RS-FEC LPI SIGNALING

Adee Ran, Intel Corp.

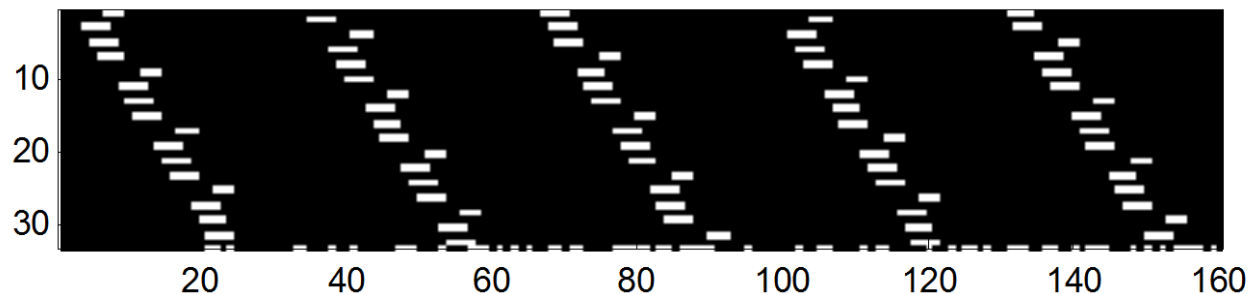
- Plot below shows the structure of a codeword comprising only // characters.
 - Most of the bits are zero (black)
 - “1” bits (white) appear only in the block type octets (four ones, except at the beginning of a transcoded block) and the RS-FEC parity field (random bits used in this example). Only ~7% of the bits are “1”.
- For easy visualization, the 5280 bits are shown in chunks of 160 bits from left to right.

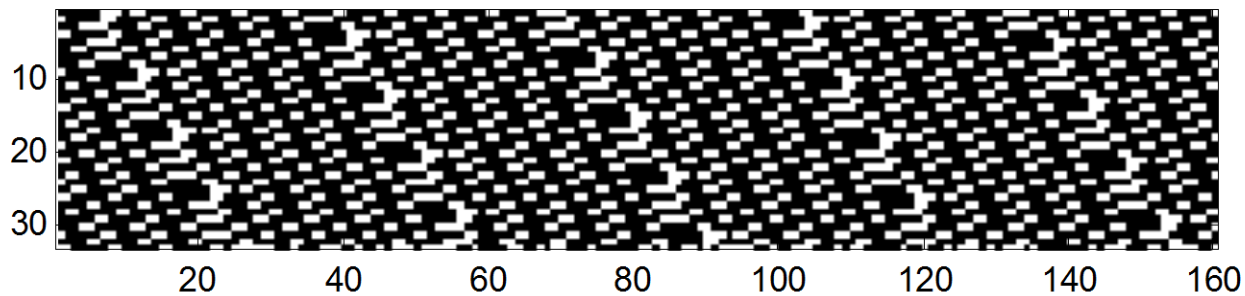
- Plot below shows the structure of a codeword comprising only /LI/ characters in a similar fashion.
 - There are more “1” bits and transitions than in the // case, but pattern is still biased toward 0 (75% of the bits).

Effect of change on codeword contents

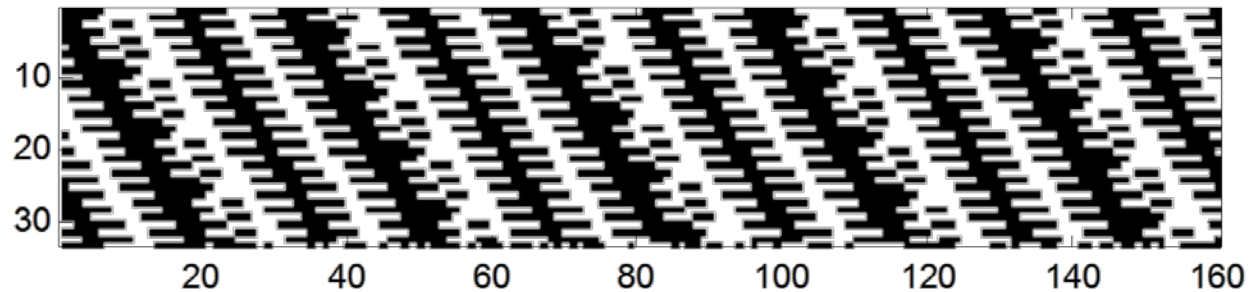
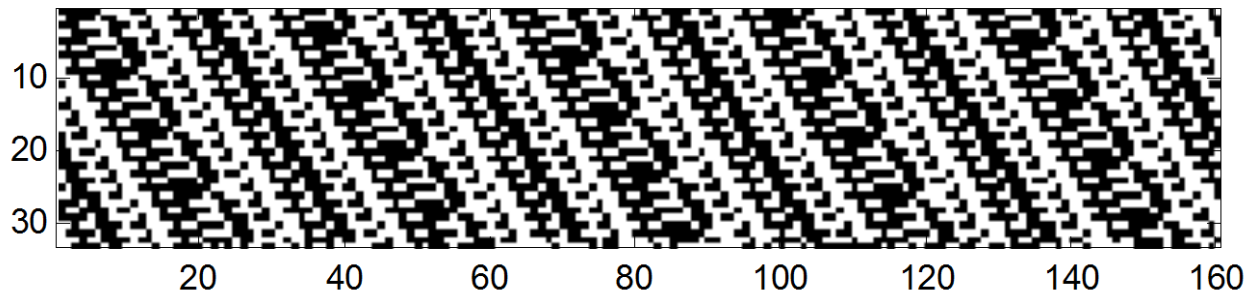
- After the RS-FEC descrambles the PCS blocks, if `bypass_scrambler=1`, modify each block by inverting every other group of 7 bits (control character) in the 56 bits that hold the payload.
- Example: for block type `0x1e`, which is followed by eight 7-bit groups `C0..C7` – invert `C0`, `C2`, `C4` and `C6`.
- This will keep the pattern easy to synchronize on for the receiver, and will restore DC balance in the two cases of `/I/` and `/LI/`.
- The receiver will reverse this inversion effect on the data sent to the PCS.

- DC balance and transition density are achieved in both cases:
 - Modified “idle” pattern

- Modified “LI” pattern
